April 27, 2021

**NOTICE OF ADDENDUM
ADDENDUM NO. 2
CONTRACT NO. 8576**

**NORTH BROOKS STREET, FAHRENBROOK COURT AND COLLEGE COURT RESURFACING
ASSESSMENT DISTRICT - 2021**

SEWER UTILITY PLAN & PROFILE - COLLEGE CT
N BROOKS ST, FAHRENBROOK CT & COLLEGE CT RES ASMNT DIST-2021
U-3

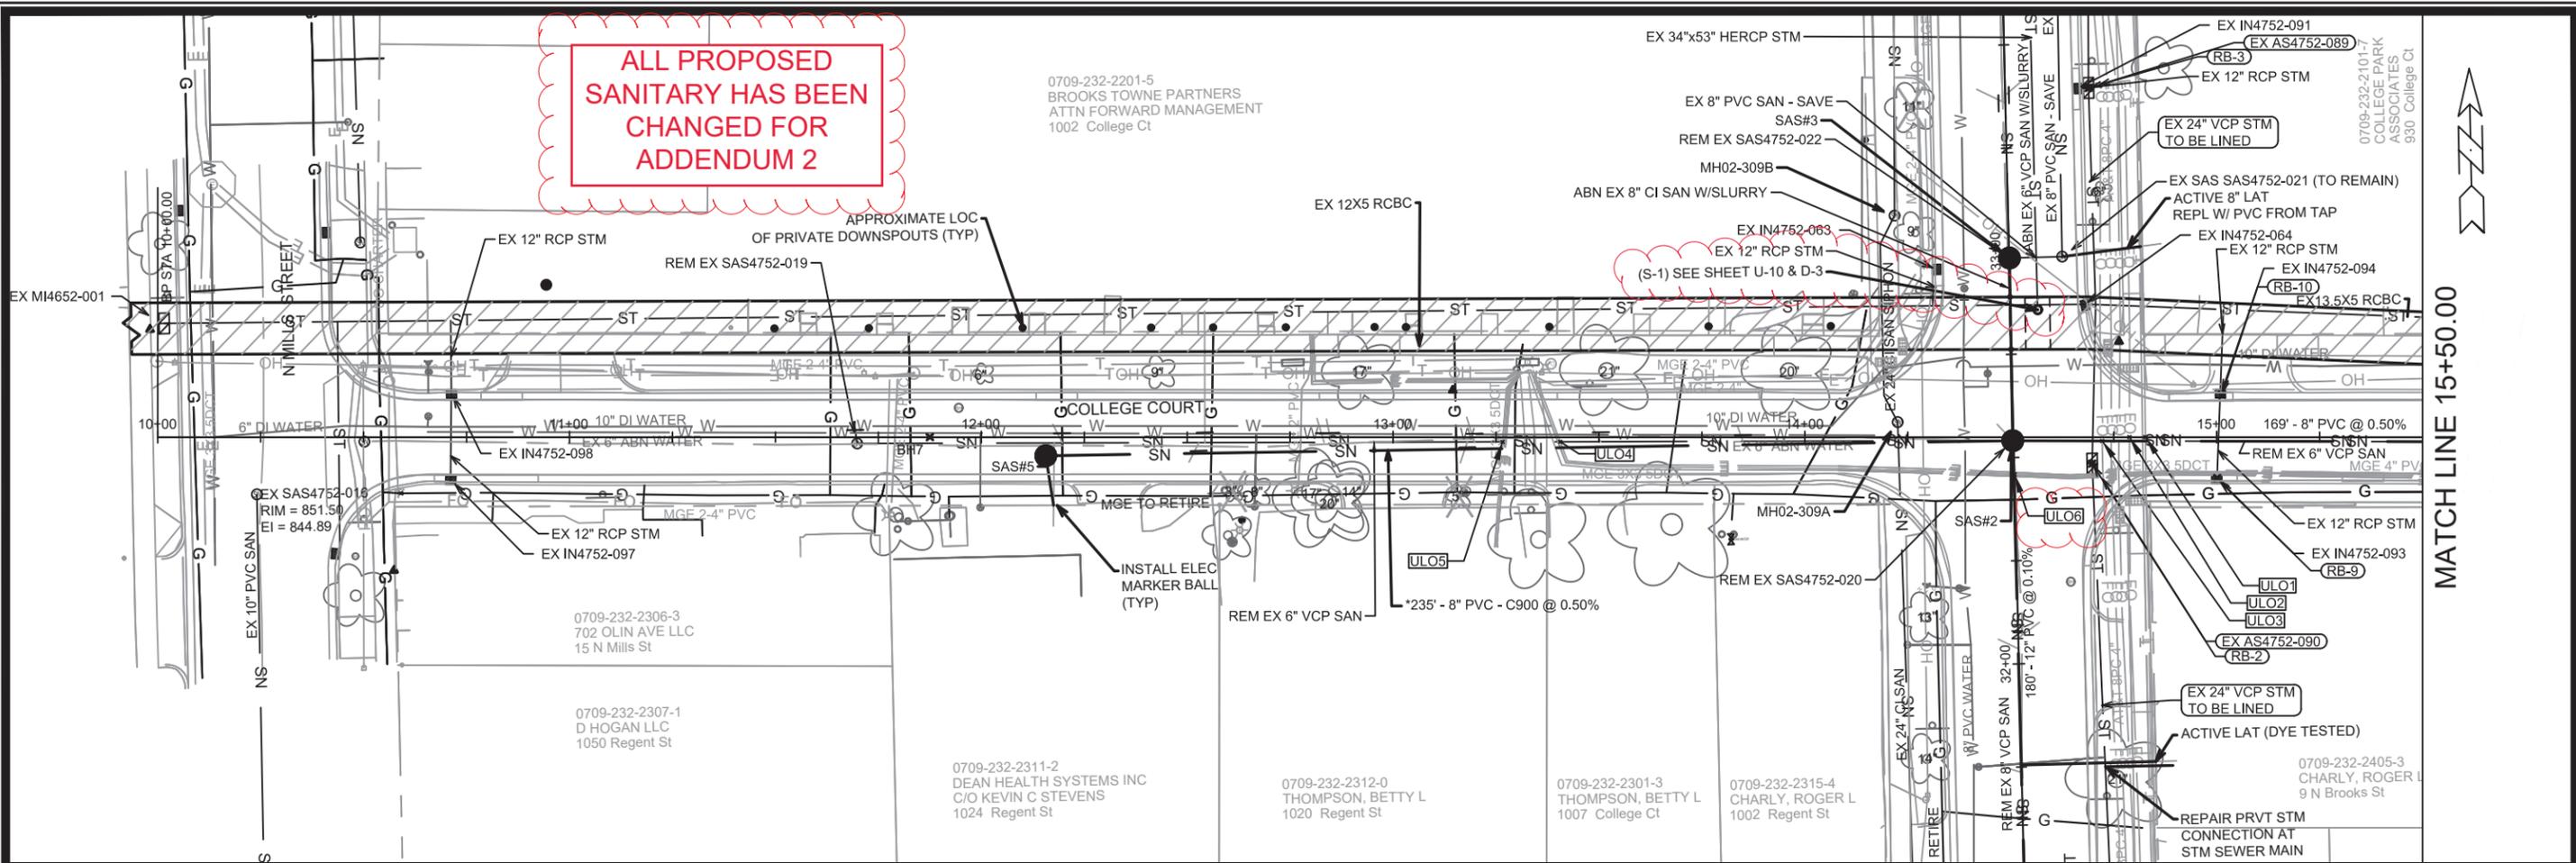
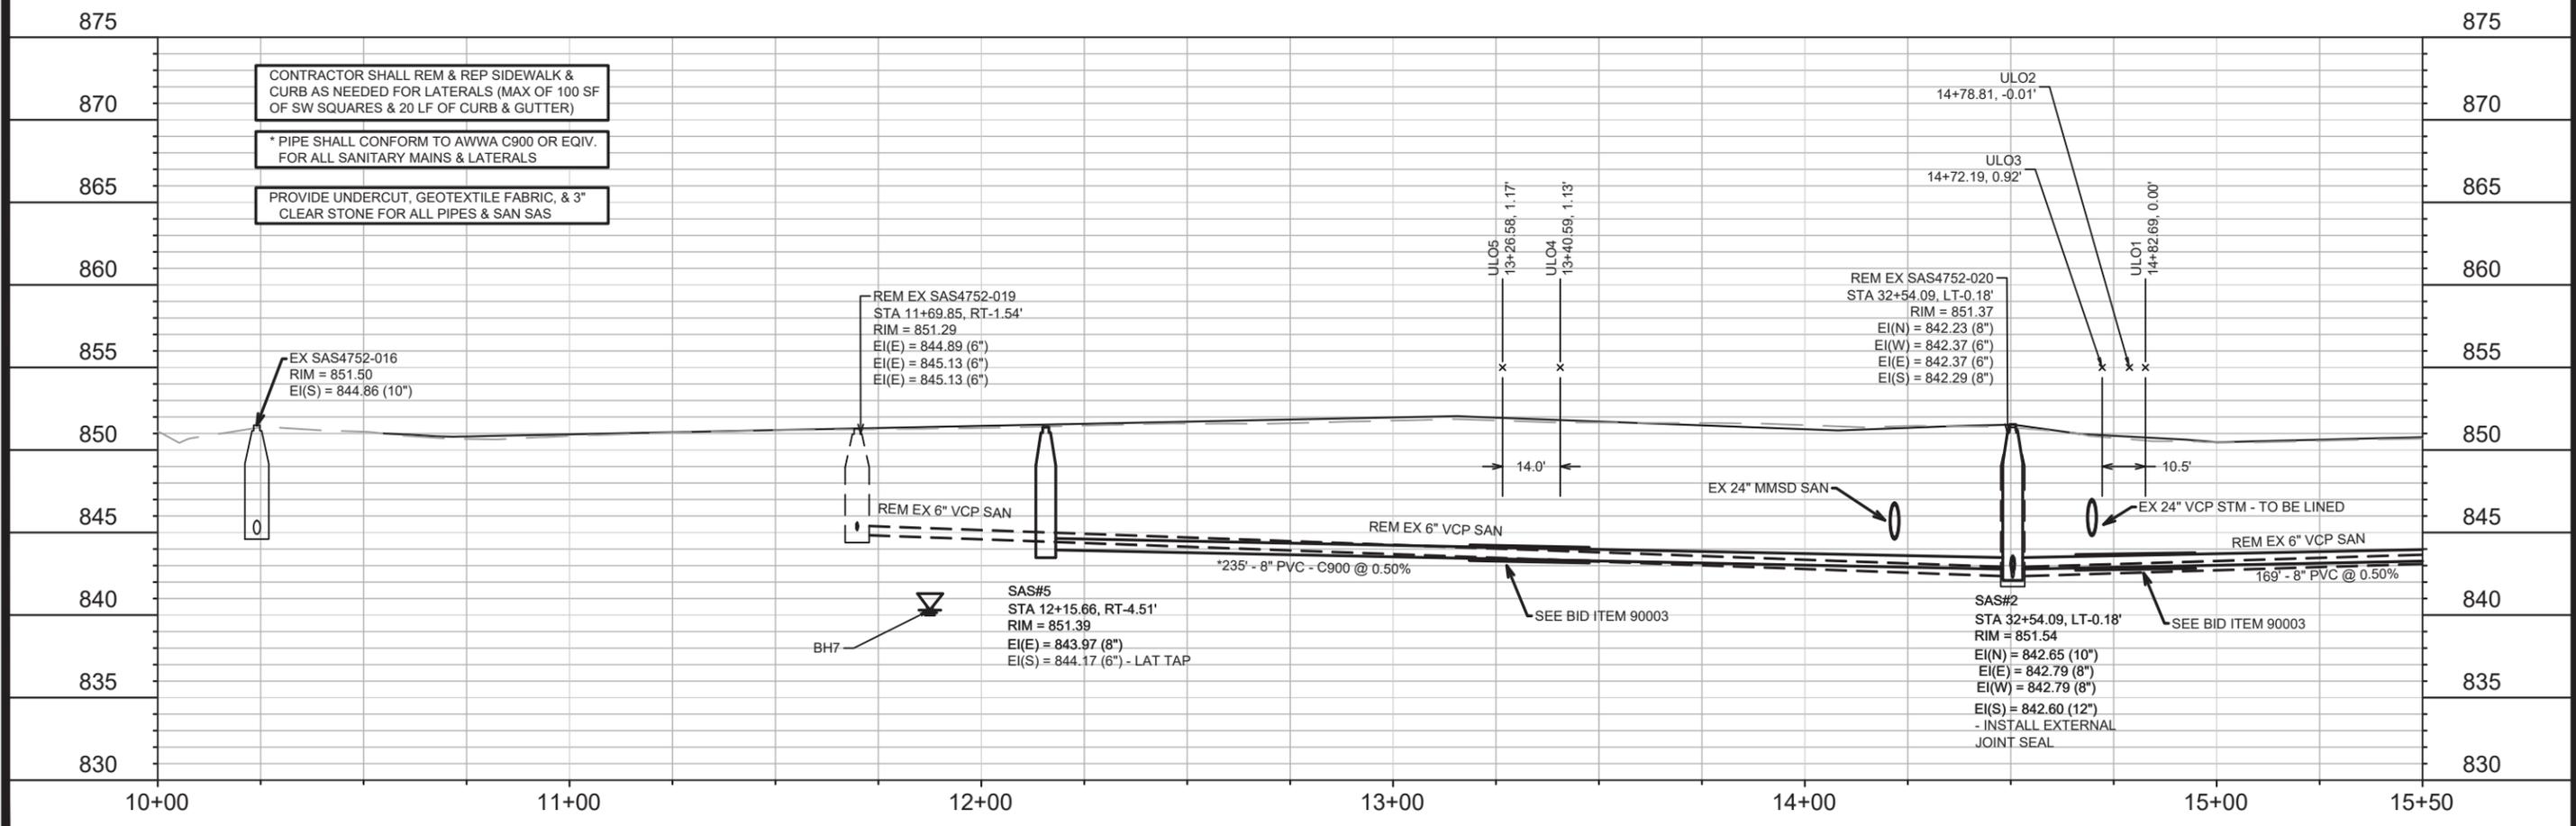
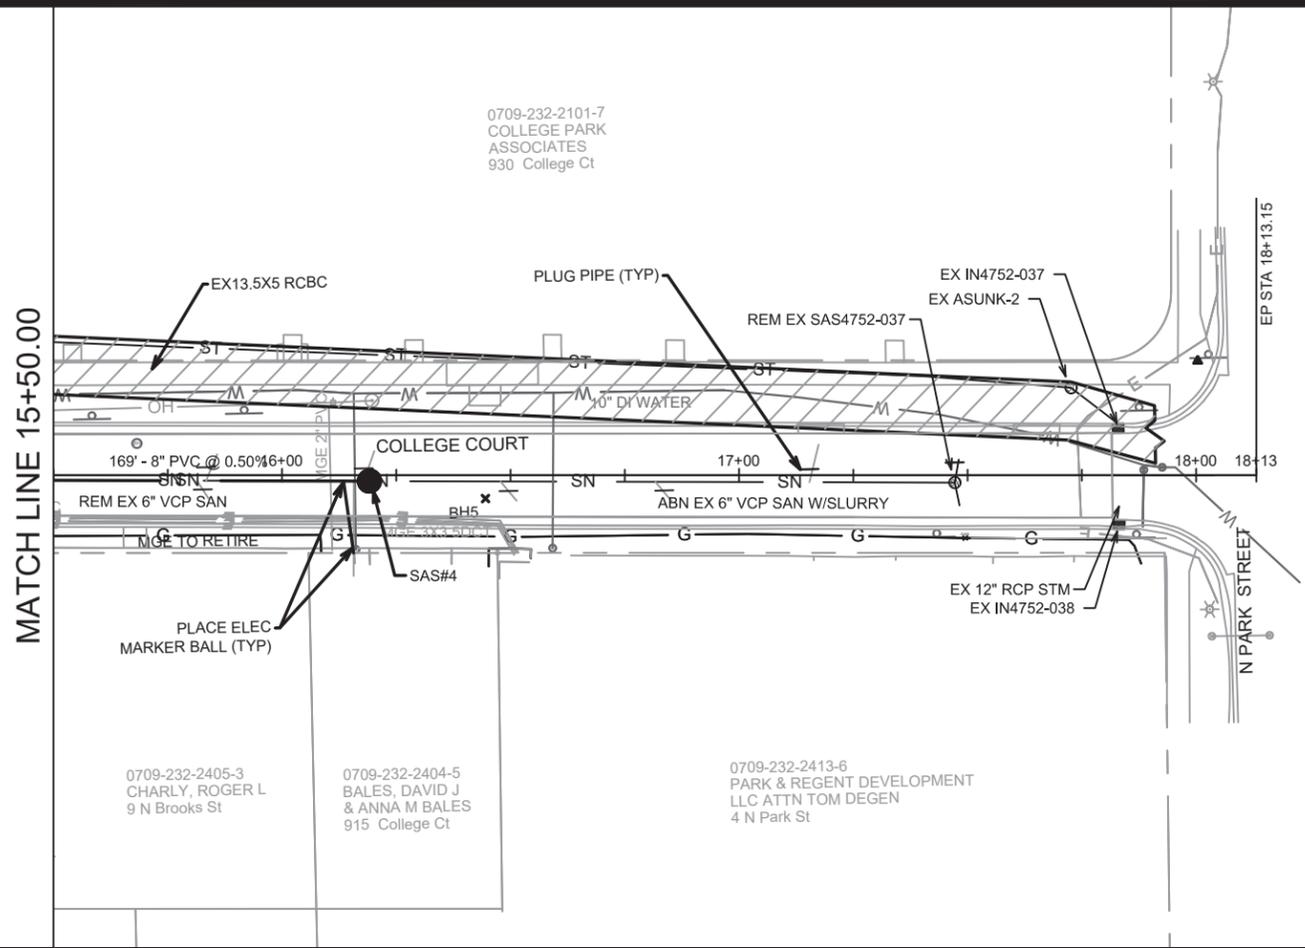
Remove and replace attached page U-1 to U-8: Updated plans with revised sanitary sewer layout.

**ALL PROPOSED
SANITARY HAS BEEN
CHANGED FOR
ADDENDUM 2**

- CONTRACTOR SHALL REM & REP SIDEWALK & CURB AS NEEDED FOR LATERALS (MAX OF 100 SF OF SW SQUARES & 20 LF OF CURB & GUTTER)
- * PIPE SHALL CONFORM TO AWWA C900 OR EQUIV. FOR ALL SANITARY MAINS & LATERALS
- PROVIDE UNDERCUT, GEOTEXTILE FABRIC, & 3" CLEAR STONE FOR ALL PIPES & SAN SAS

13180	ADDENDUM 2	DATE	BY	U-5
13180	REVISION	Date: 4/26/2021 3:54 PM		
13180	MARK	Scale: #####		
13180	DAO

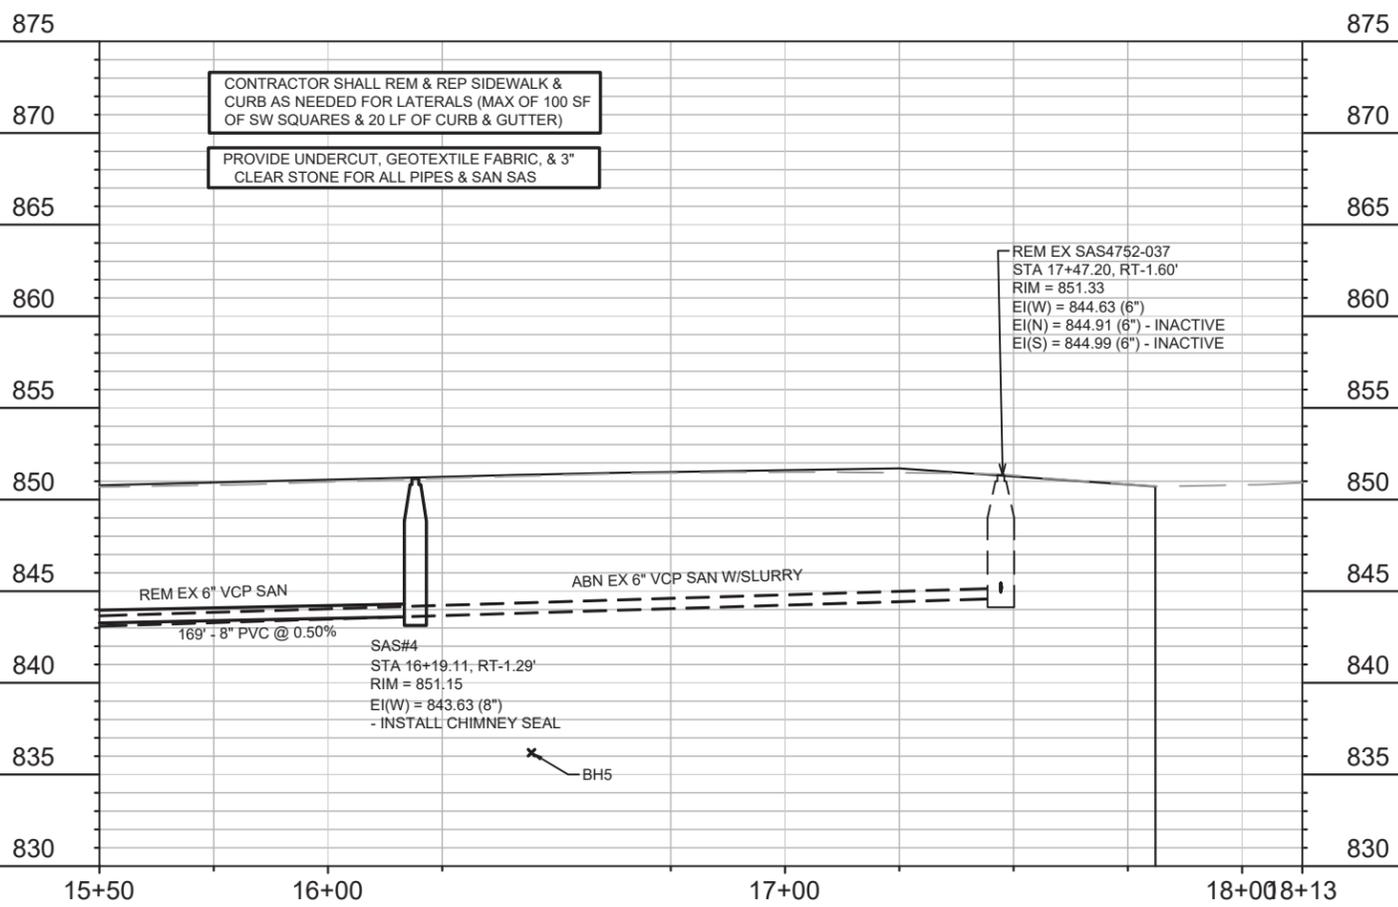
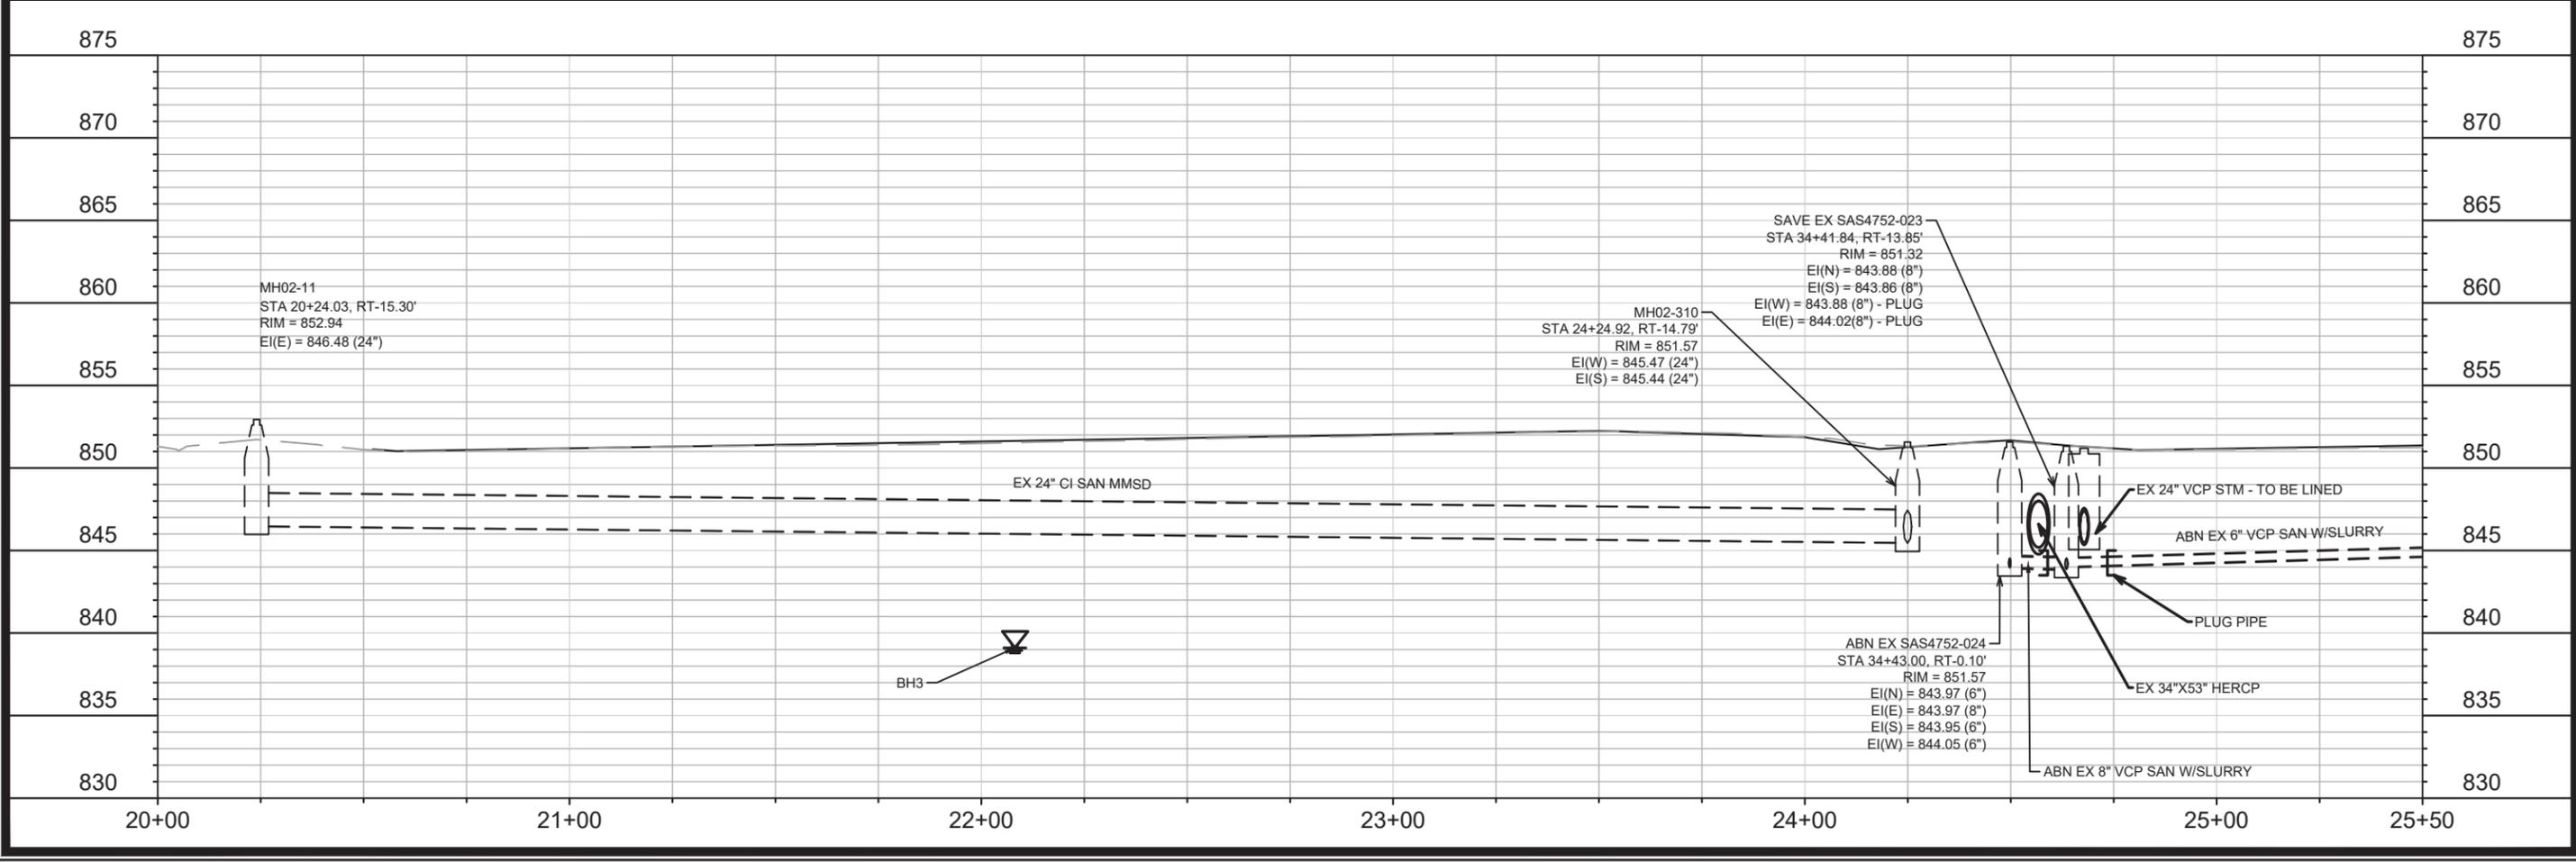
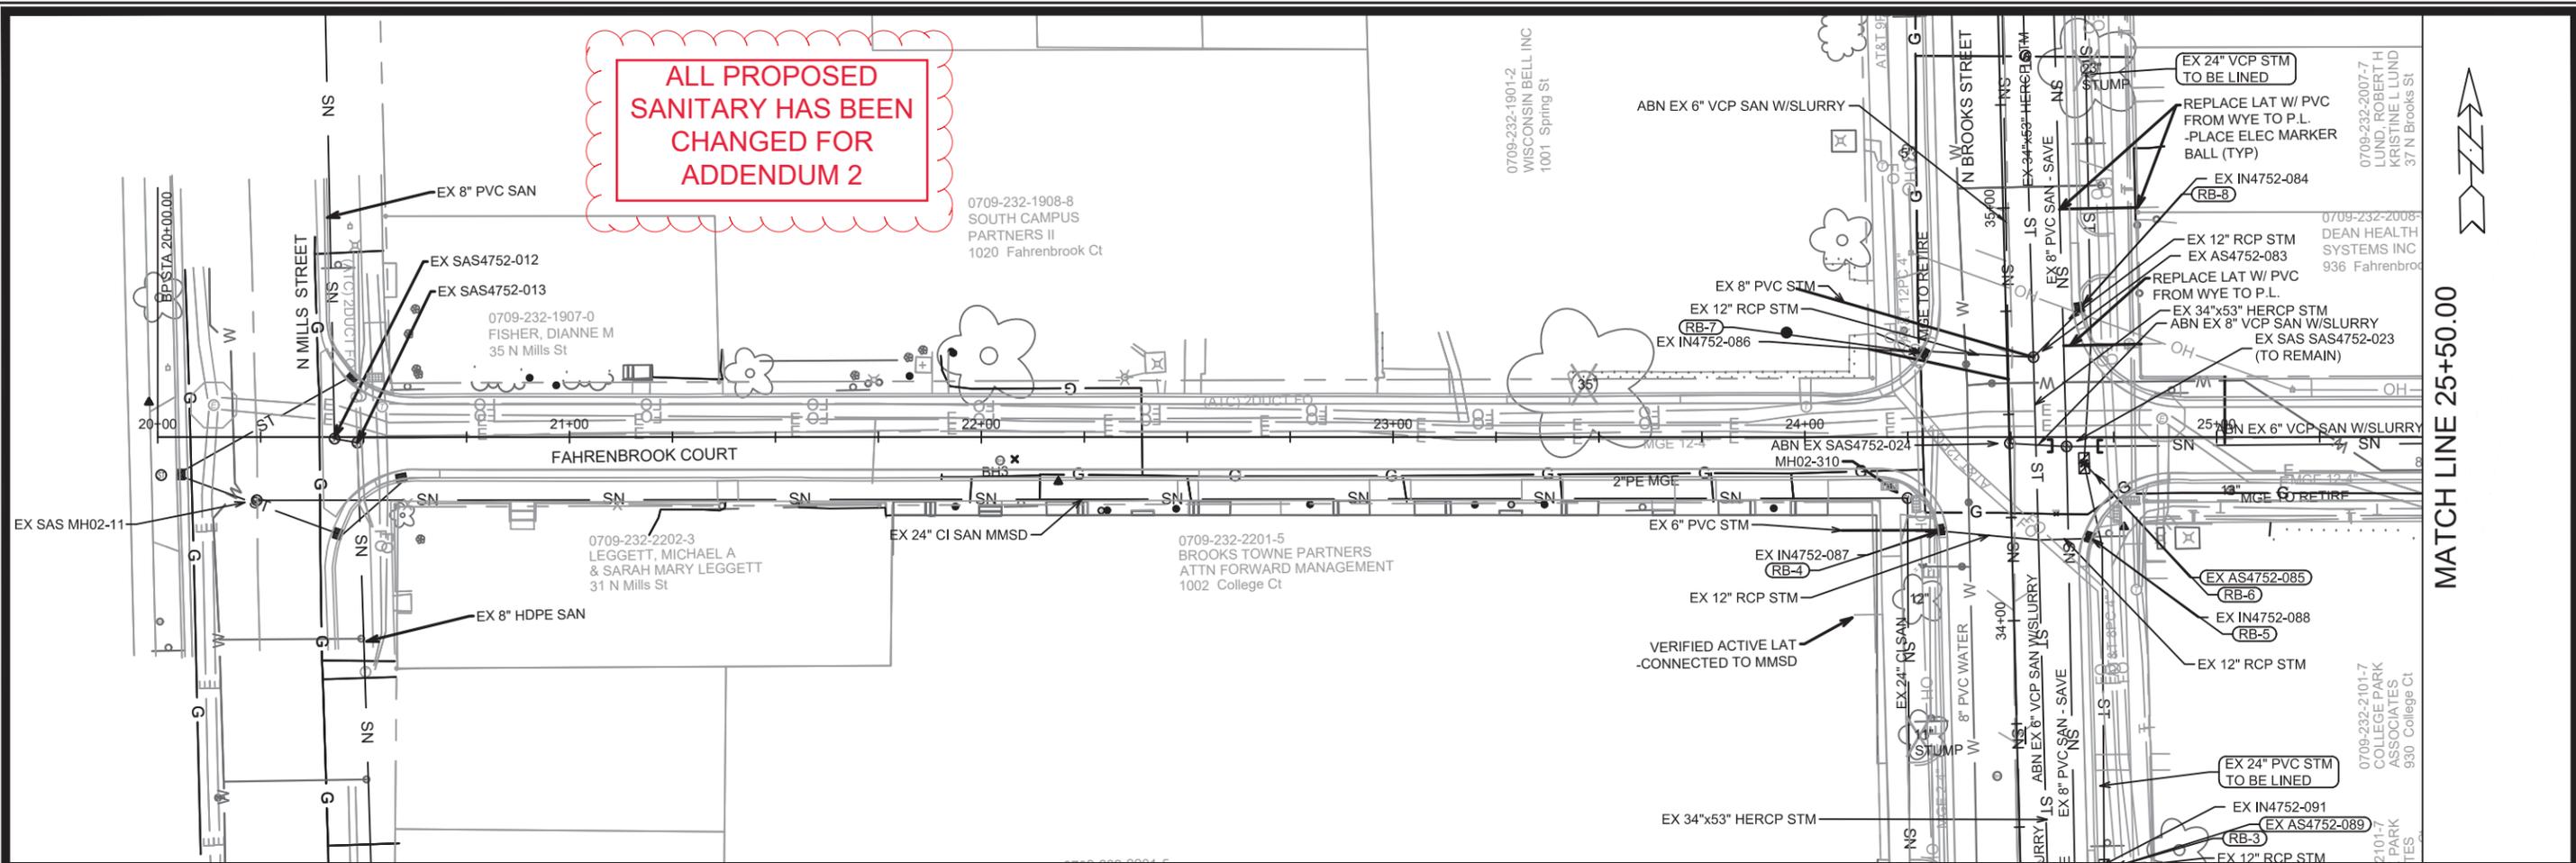
ALL PROPOSED
SANITARY HAS BEEN
CHANGED FOR
ADDENDUM 2

**ALL PROPOSED
SANITARY HAS BEEN
CHANGED FOR
ADDENDUM 2**
